FINAL PLAT
THE LEGACY ADDITION
AN ADDITION TO WICHITA SEDGWICK COUNTY, KANSAS

Re: S/D 98-55 -- Final Plat of THE LEGACY ADDITION

Re: S/D 98-55 -- Final Plat of THE LEGACY ADDITION

CASE NUMBER: S/D 98-55 - THE LEGACY ADDITION (formerly SOUTH PARK 3RD ADDITION)

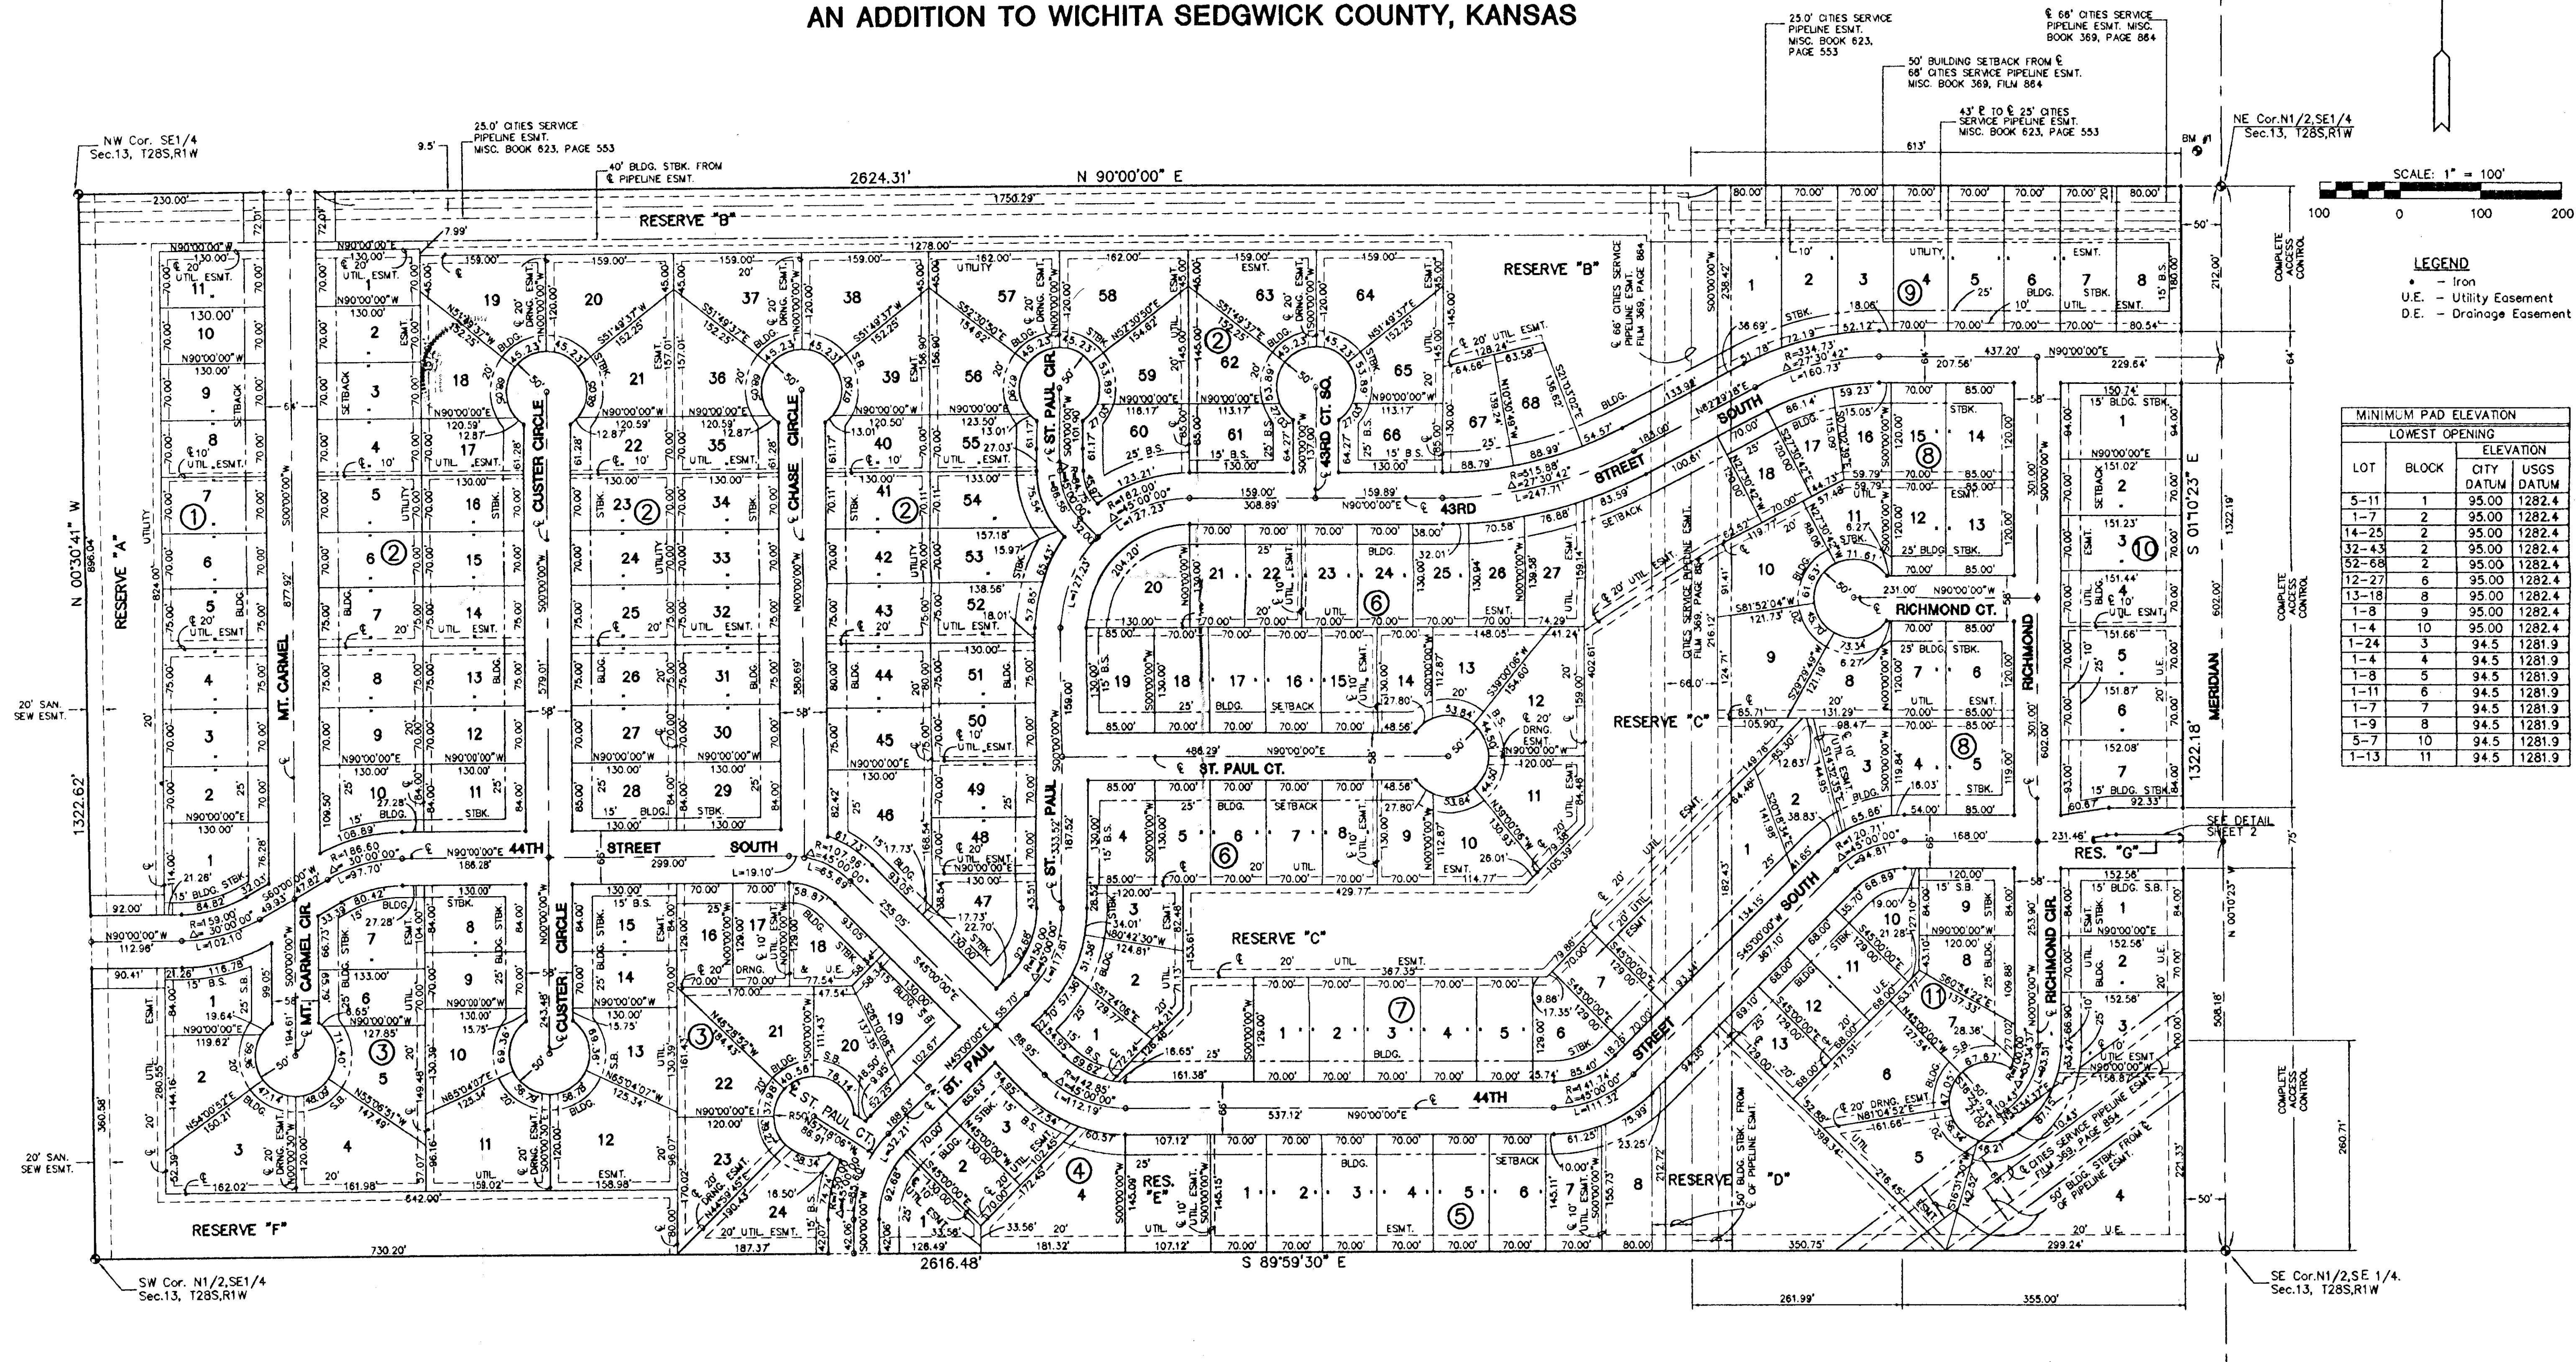
- A. The applicant shall guarantee the extension of City water and sanitary sewer to serve the lots being platted. City Engineering needs to indicate if any additional guarantees are required. A respread agreement will need to be submitted for any existing special assessments.

- C. City Engineering needs to comment on the status of the applicant's drainage plan. The drainage plan is approved. The lots adjacent to the pond and drainage ditch need minimum building pad elevations.

- D. The applicant shall guarantee the paving of the proposed interior streets. This guarantee shall include the paving of 44th St. South to a collector status. As a collector street, sidewalks will be required along both sides of 44th St. South. Sidewalks will be required along one side of all 64-ft streets (Mt. Carmel, Chase, St. Paul and 43rd St. South).

- G. The tie point at the southeast corner of the plat should be revised to reference the "SE 1/4".
- H. The applicant shall submit a copy of the instrument which establishes the pipeline easements on the property, which verifies that the easements shown are sufficient and that utilities may be located adjacent to and within the easements.

- I. The applicant's agent shall determine any setback requirements for the pipelines by researching the text of the pipeline agreements. If a setback from the pipeline easements is provided for in the pipeline easement agreements, it shall be indicated on the face of the plat.

- J. Lot 1 through 8 of Block 9 exceed the lot depth-to-width standard of 2½ to 1. A waiver from this provision will be needed for approval of the plat.

- M. A guarantee shall be provided for the installation of a temporary cul-de-sac for the termination of Mt. Carmel. The right-of-way dedication shall be provided by the plat or by separate instrument, with the vacation of the temporary cul-de-sac being effective upon the extension of Mt. Carmel northward.

- O. Fire Department needs to comment on Mt. Carmel which is 800 feet in length, exceeding the 600-ft standard imposed by the Subdivision Regulations. The length of Mt. Carmel is acceptable since it is a stub street. A temporary turnaround is required.

- Q. Fire Department needs to comment on the plat's street names. It would appear that St. Paul Circle should be renamed St. Paul Court. *Fire Department has contacted the Applicant regarding revised street names. Chase shall be renamed St. Paul. Chase Court shall be renamed St. Paul Court. 43rd Street South Court shall be renamed 43rd Court South.* \

- Y. The representatives from the utility companies should be prepared to comment on the need for any additional utility easements to be platted on this property. *KG&E and Southwestern Bell has requested additional easements which have been denoted on the final plat.*
